8th CSPCWG Meeting  
Turku, Finland, 29 November – 2 December 2011

Paper for Consideration by CSPCWG  
Coloured Light Flares

**CSPCWG7 - Action 17****Use of generic magenta light flare on multicoloured charts**

Consolidated Responses to CSPCWG Letter 06/2011

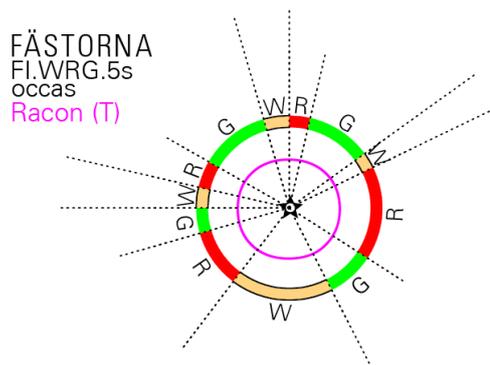
Question 9: Yes, what we need clear guidance that allows:

this:

to be generalized for example like this:

There are some cases, like the one above, in our charts, where the light becomes “over-prominent” when the sectors are shown. The light in the example is a very minor, occasional light, which still needs to be charted. When shown as in the first picture above, it draws focus from the single-coloured, more major lights in the same area.

We have tried the one below, but it got misinterpreted by the chart users.

The same method would also be used in congested areas to simplify the presentation of sector lights to reduce clutter.

It would be helpful to know in what way this was misinterpreted. It may be that the mariner assumed the flares represented the actual sectors?
